MEMORANDUM

Subject: Third Review – Lakeside at Sutter Pointe Master Plan Documents

Subject: Lakeside at Sutter Pointe (900 acres +/-) – Drainage Analysis Review

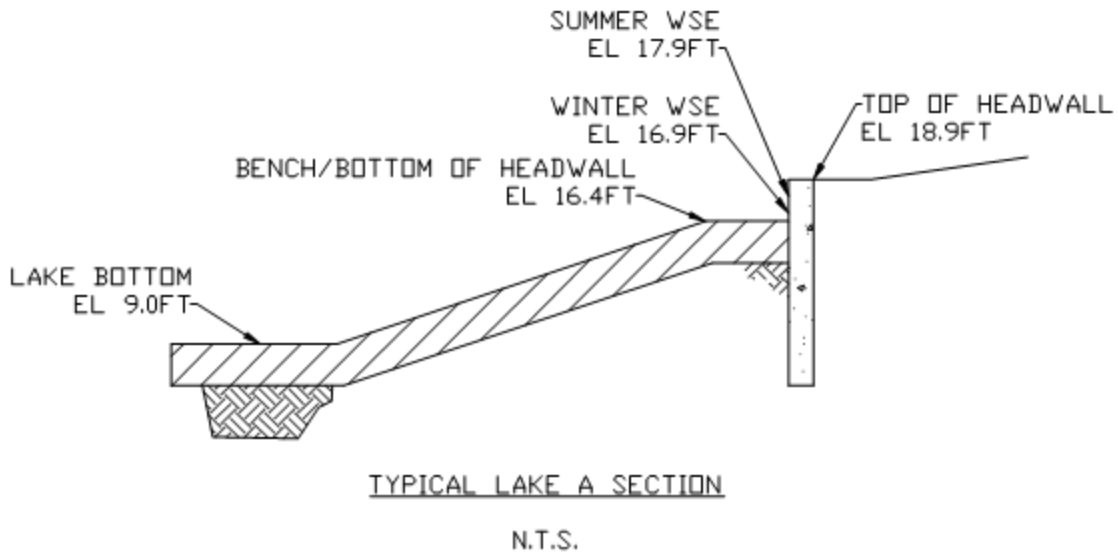
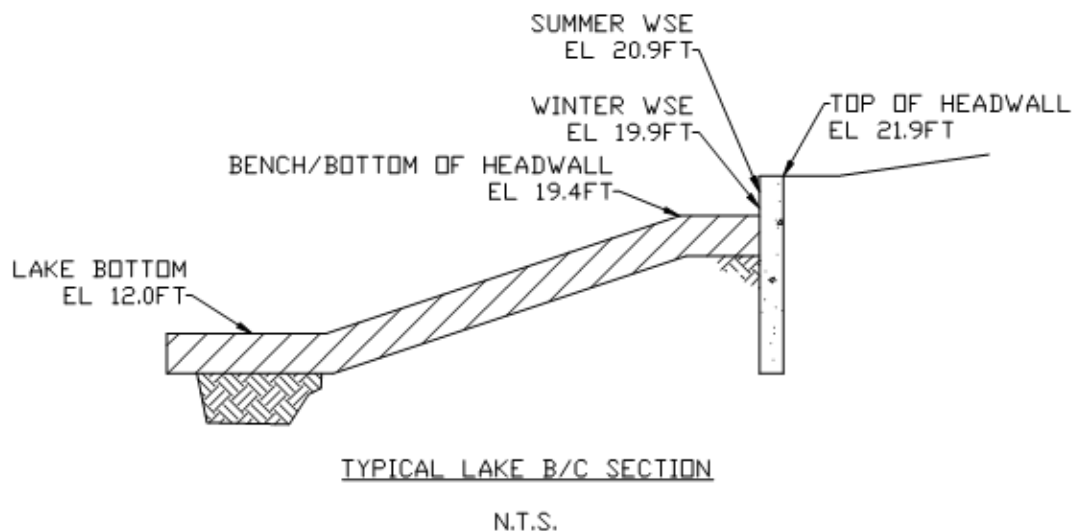
- The emergency spillway for all lakes appear to be at the normal summer elevation with no freeboard and the Stage-Storage tables provide storage volumes well above the emergency spillway and top of headwall. In addition, the max stage for both the 10 and 100-year events are well above the emergency spillway. It appears that these basins are not designed to detain the 10 and 100-year events as each will use the emergency spillway. Since the design hinges on utilizing pumps to control the discharge to RD 1000 to a maximum of 62 cfs, these spillway elevations do not appear to accomplish the design goal. Recommend the basins be designed to contain up to the 100-year event to control flow and limit the use of emergency spillways.
